REVIEW REPORT

PITT MEADOWS AIRPORT
SEWAGE DISPOSAL FACILITIES

Environment Canada,
Environmental Protection Service,
Federal Activities Abatement Group,
Pacific Region.

November, 1973.

FIGURE I. PITT MEADOWS AIRPORT - EXISTING SEWAGE DISPOSAL FACILITIES

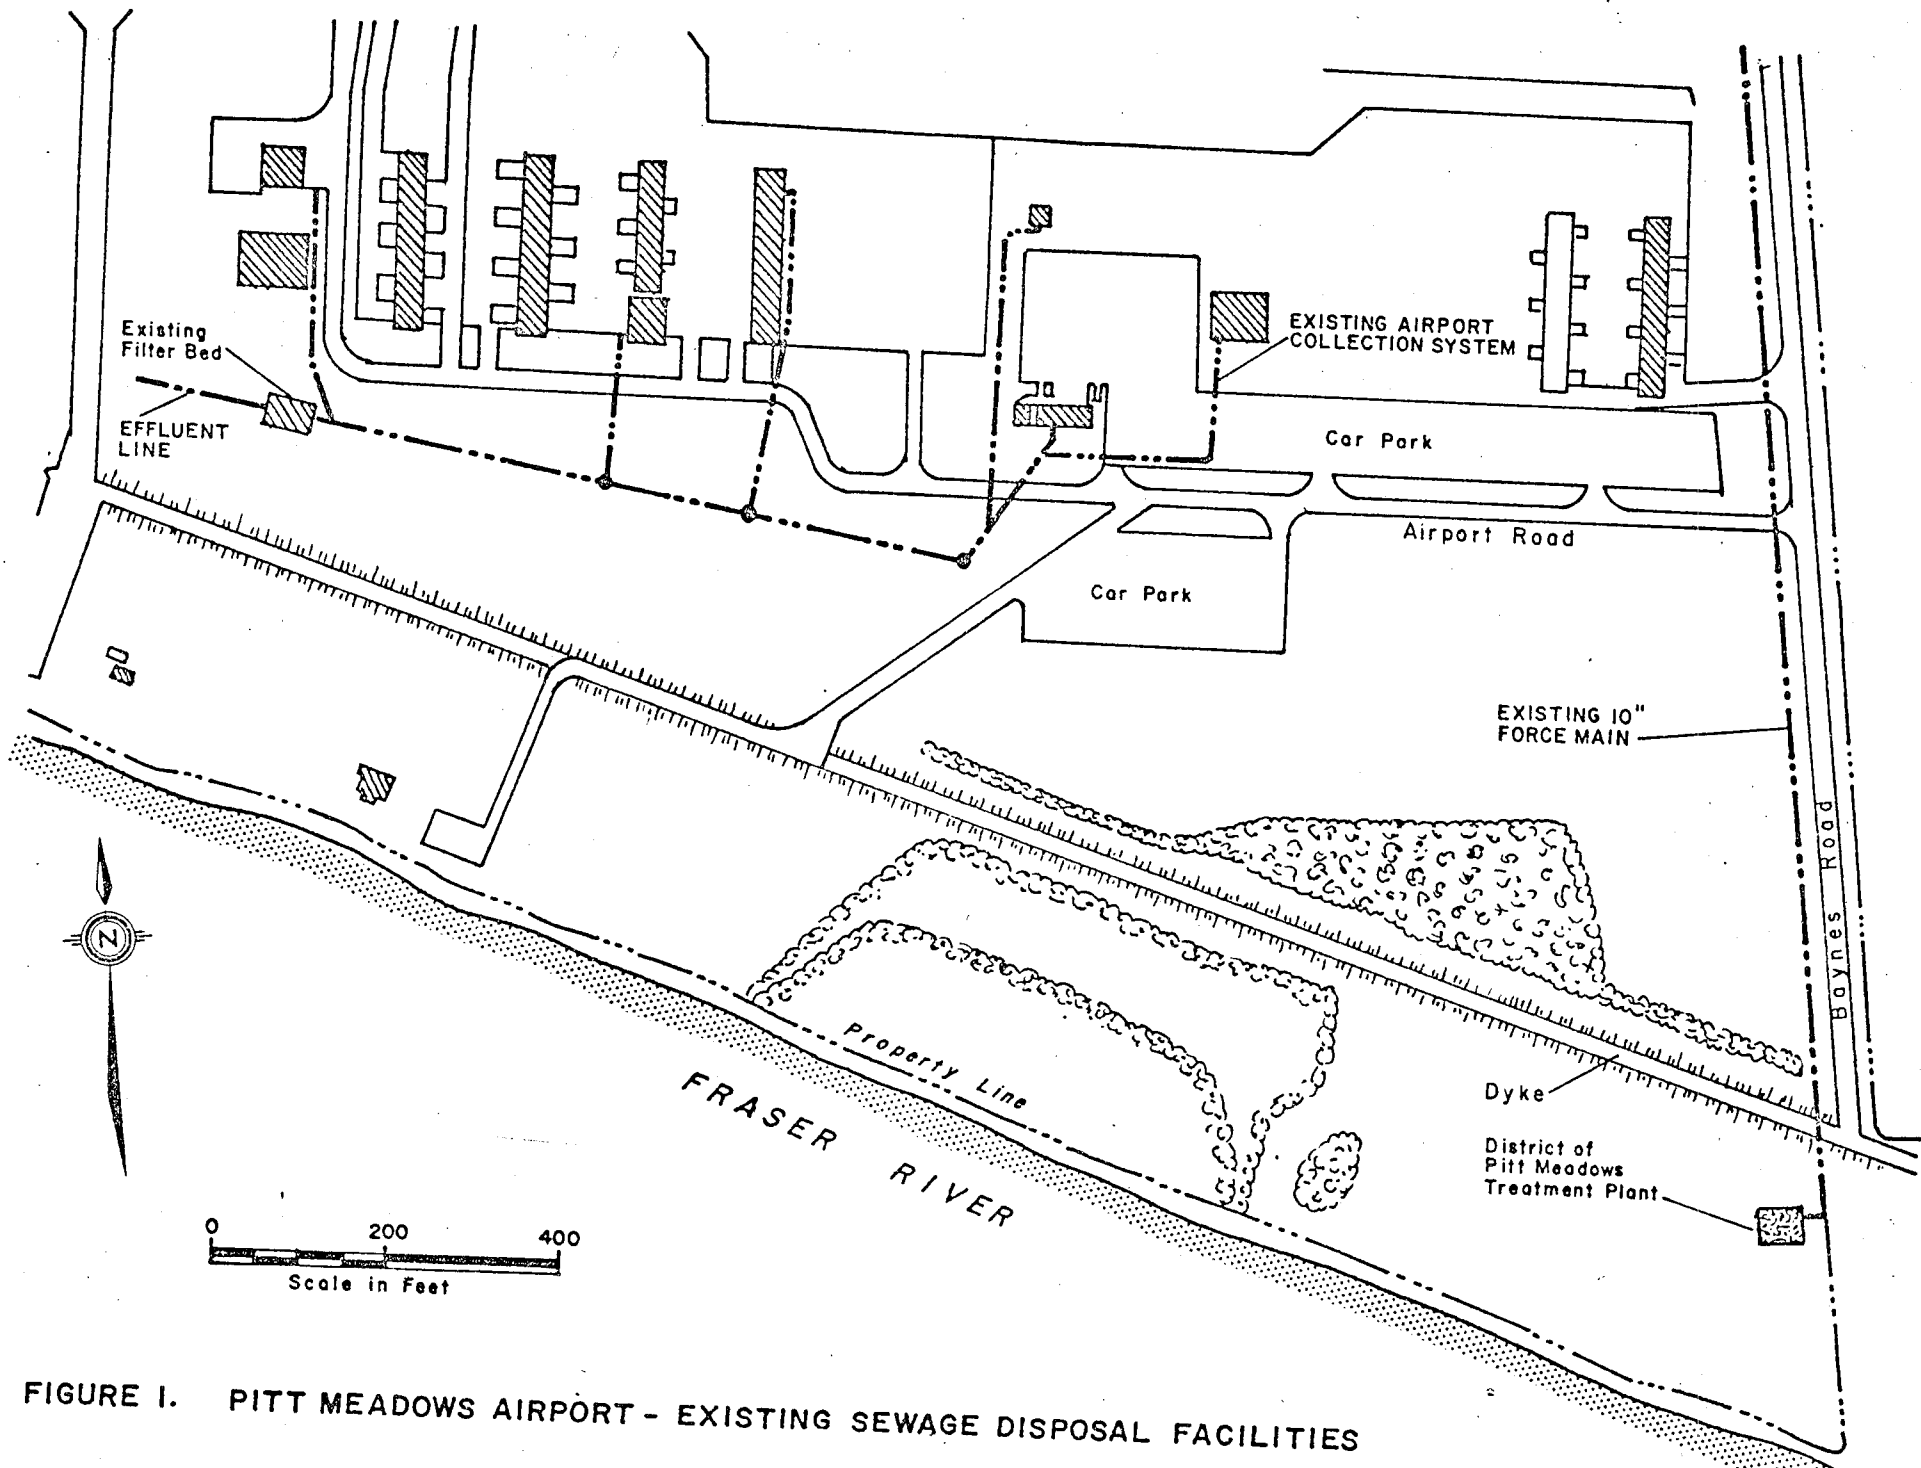
There have been no changes to the facilities since the 1970 report and there are no new connections to the airport collection system. Chlorination of the effluent from the filter bed is still not being carried out. The collection system is reportedly in good condition but most of the grades on the 4" diameter building connection sewers are apparently quite low (generally less than 1%) and will probably prove inadequate for carrying raw sewage if the existing septic tanks are disconnected.

Command Aviation, which is located in the North East corner of the airport property, is not connected to the airport collection system and presently disposes of its sewage to a septic tank and tile field system. Apparently due to a high water table the tile field has failed in the past. The District of Pitt Meadows' sewage pump station

is located within a few hundred feet of Command's property and connection of their sewage to this facility should be a simple procedure.

It is proposed to bypass the septic tanks and intercept the existing airport flows and divert them to the Pitt Meadows sewage treatment plant. Command Aviation flows should be intercepted separately and conveyed directly to the Pitt Meadows pump station on Baynes Road. Although more detailed investigation is required it would appear that the existing gravity collection system is inadequate to handle raw sewage flows, particularly insofar as the grades in the building connection sewers are concerned. A decision to install a new collection system would be reinforced by the fact that the existing collection system would, undoubtedly, be unable to handle the flows from the proposed airport expansion without an added pump station and force main.

FIGURE 2. PITT MEADOWS AIRPORT - PROPOSED SEWAGE DISPOSAL FACILITIES - SCHEME I.

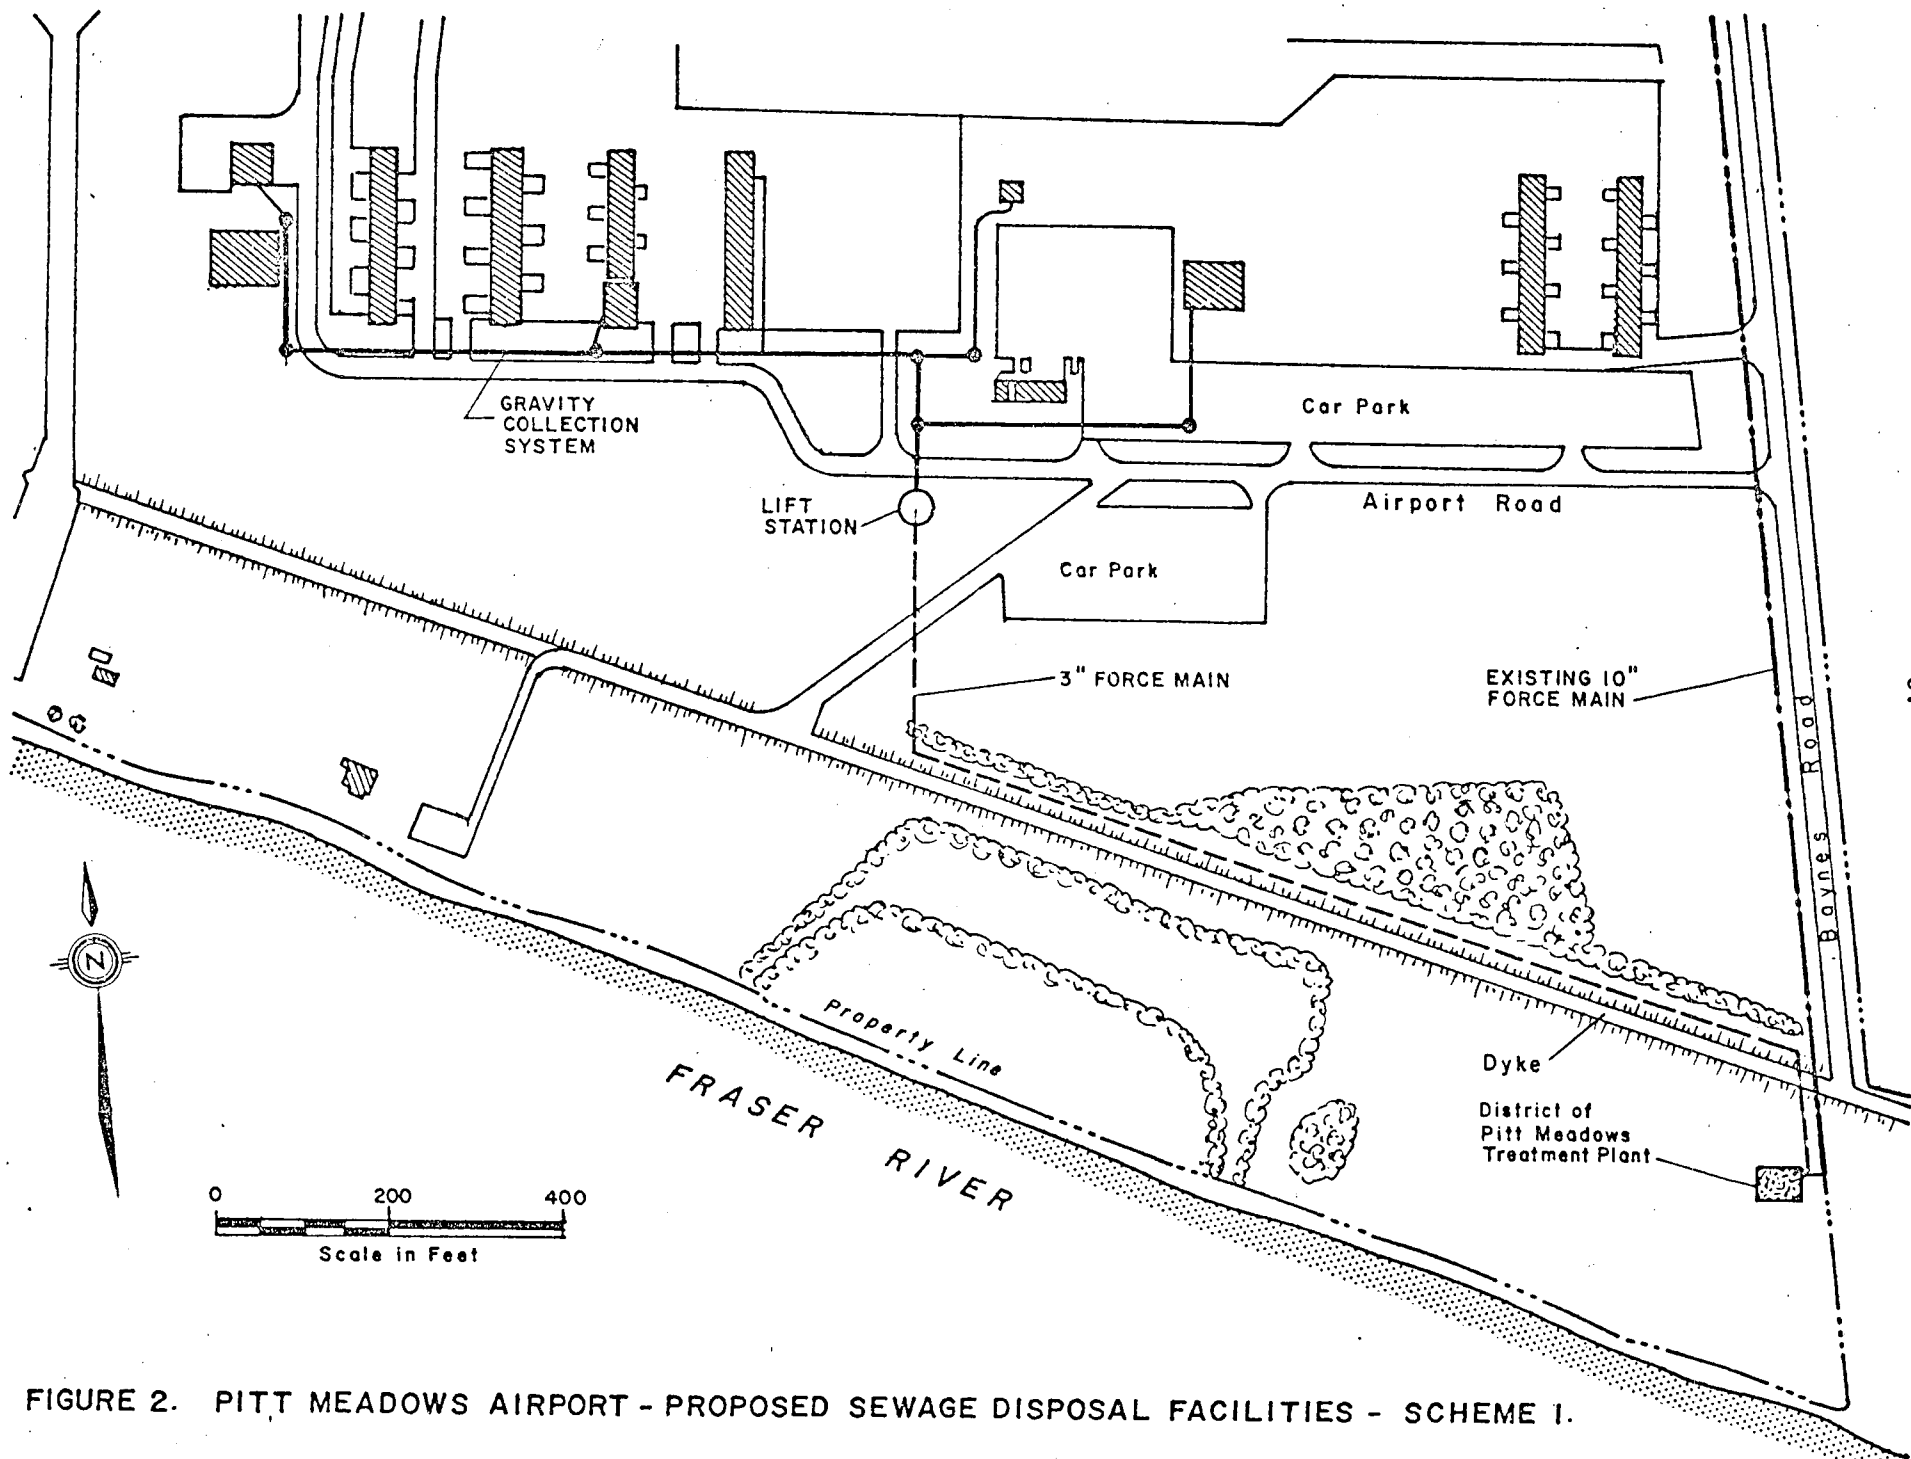
Abandon the existing collection system and construct a new gravity system, including building connection sewers, leading to a central lift station and pump the flows directly to the sewage treatment plant. Pumping of these flows into the "T" provided on the 10" force main on Baynes Road will, undoubtedly, present many design and operating problems and was not considered as a preferable

alternative to direct connection to the treatment plant. The lift station should be designed to accommodate additional flows resulting from the proposed airport expansion, and should be of sufficient depth to receive these flows by gravity.

(1) Duplex lift station, supplied and installed complete with all appurtenances, electric power service and sewage flow metering and recording device	\$15,000
(2) 1600' of 3" dia forcemain @ \$6.00/ft.	9,600
(3) 880' of 8" dia. gravity sewer @ \$12.00/ft.	10,560
(4) 560' of 6" dia. gravity sewer @ \$9.00/ft.	5,040
(5) 620' of 4" dia. building connection sewer @ \$6.00/ft.	3,720
(6) 6 manholes and 2 cleanouts @ \$500 each	4,000
(7) Connection to treatment plant	1,000
(8) Allowance for pavement restoration (1200 sq.ft @ \$1.00/ft)	1,200
(9) Allowance for removal of existing septic tanks (7 @ \$200. ea)	<u>1,400</u>
	51,520
Plus 20% contingencies	<u>10,300</u>
Total:	<u>\$61,820</u>

FIGURE 3. PITT MEADOWS AIRPORT - PROPOSED SEWAGE DISPOSAL FACILITIES - SCHEME II

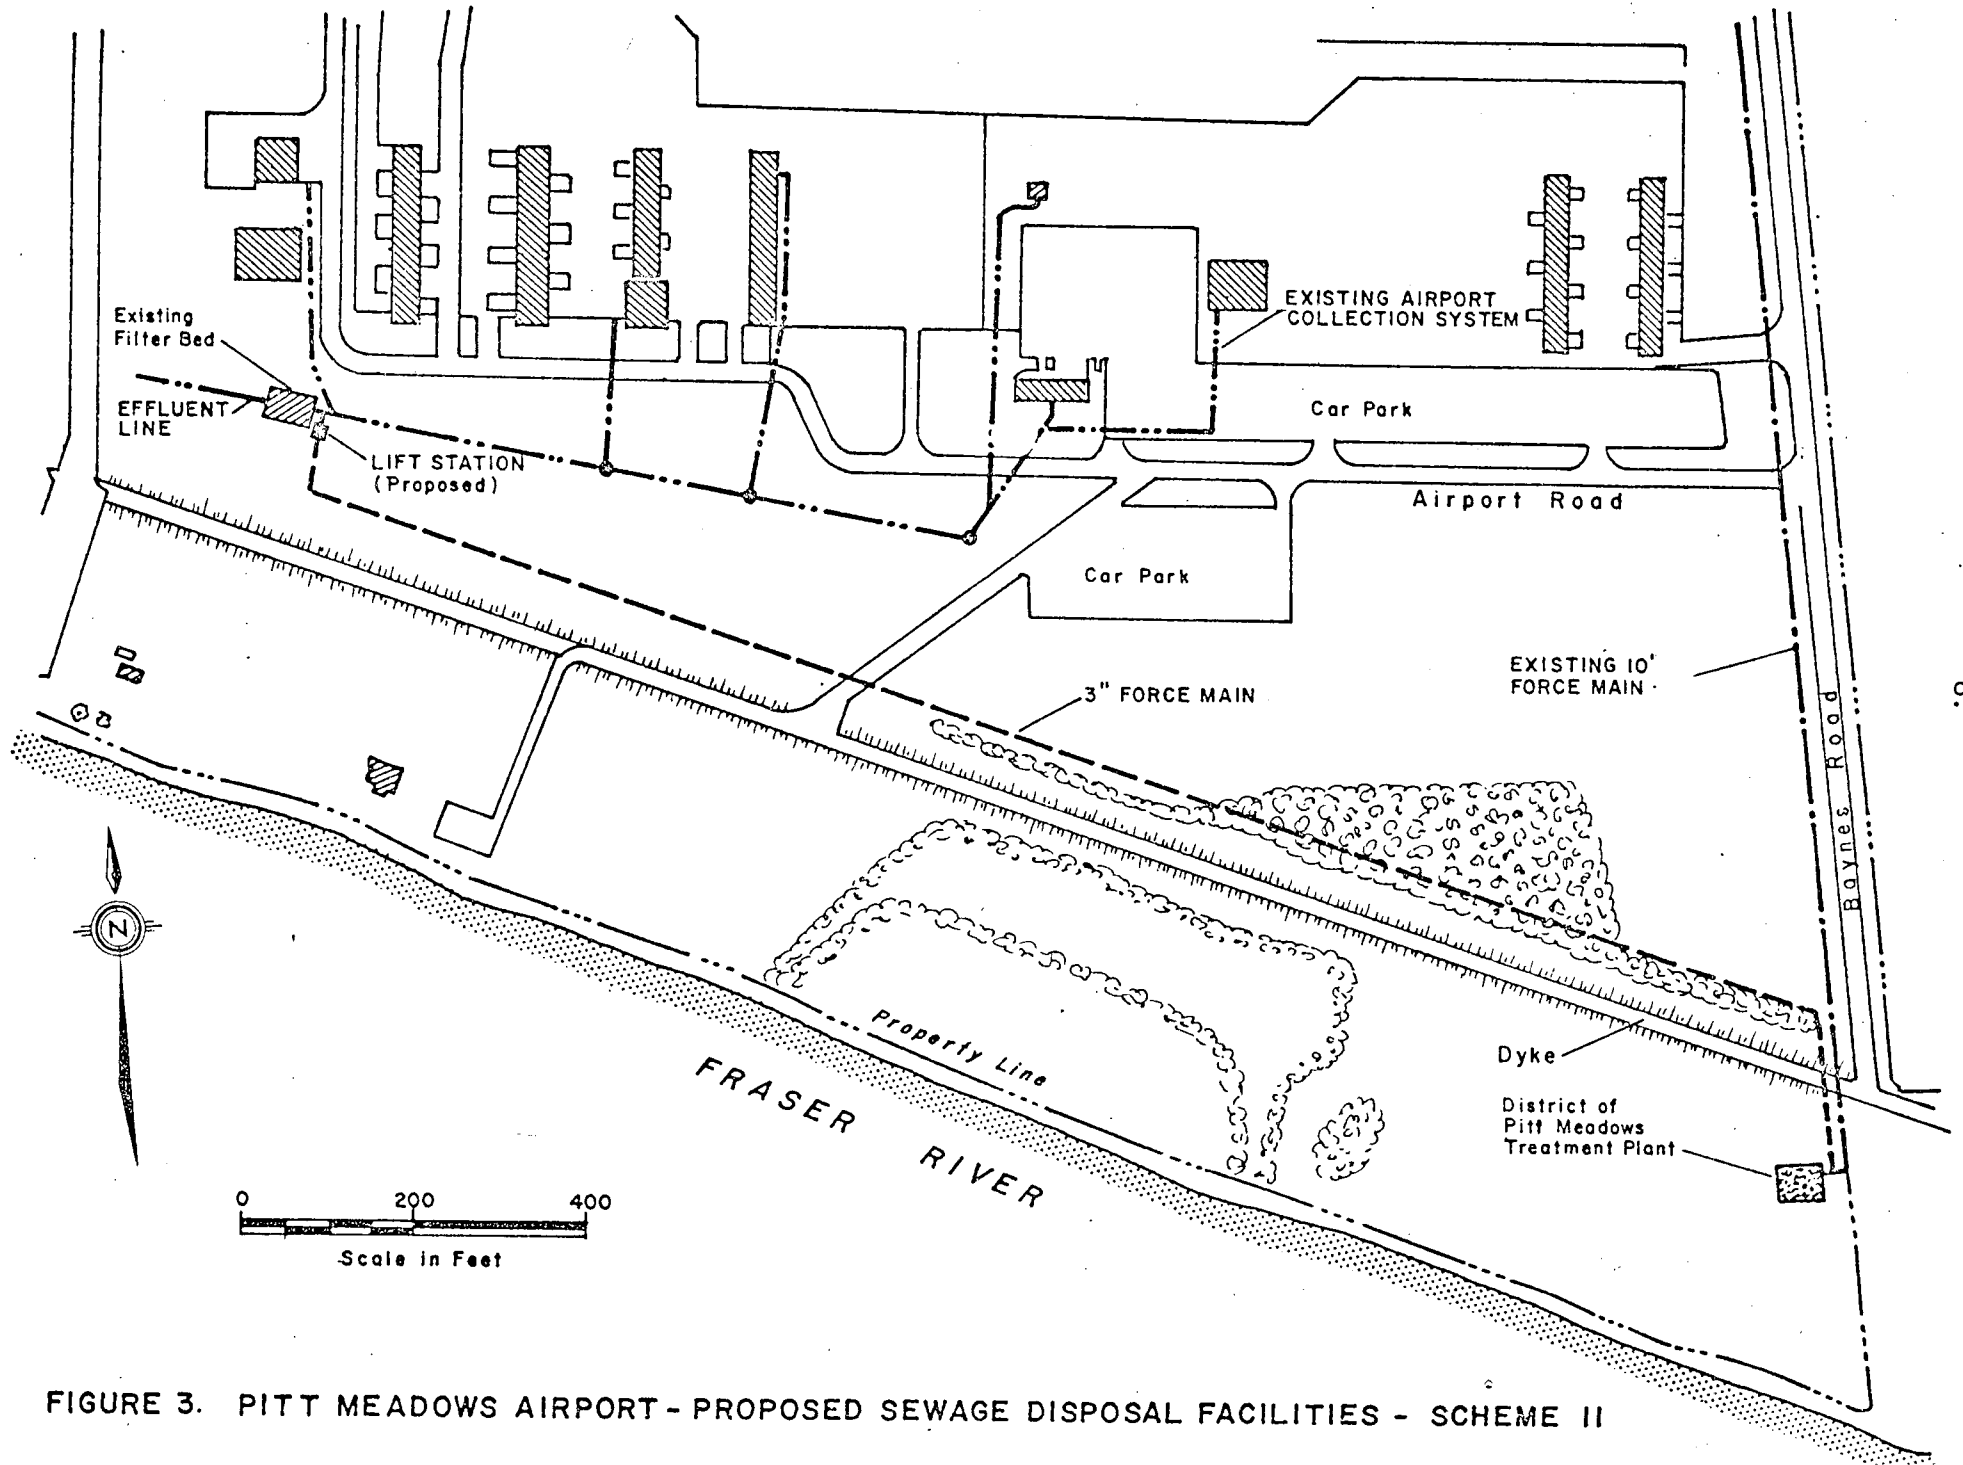
Providing further investigation proves the existing collection system adequate to handle raw sewage flows, retain the existing system and intercept the flows at the existing concrete pumping chamber. Provide a lift station and force main and pump the flows directly to the sewage treatment plant. If the proposed expansion

goes ahead, the additional flows generated will probably either have to be pumped into the existing collection system or pumped separately into the treatment plant.

(1) Duplex lift station, supplied and installed complete with all appurtenances, electric power service and sewage flow metering and recording device	\$15,000
(2) 2100' of 3" dia. forcemain @ \$6.00/ft.	12,600
(3) Connection to treatment plant	1,000
(4) Allowance for pavement restoration (200 sq. ft @ \$1.00/ft.)	200
(5) Allowance for removal of existing septic tanks (7 @ \$200. ea.)	<u>1,400</u>
	30,200
Plus 20% contingencies	<u>6,040</u>
Total:	<u>\$36,240</u>
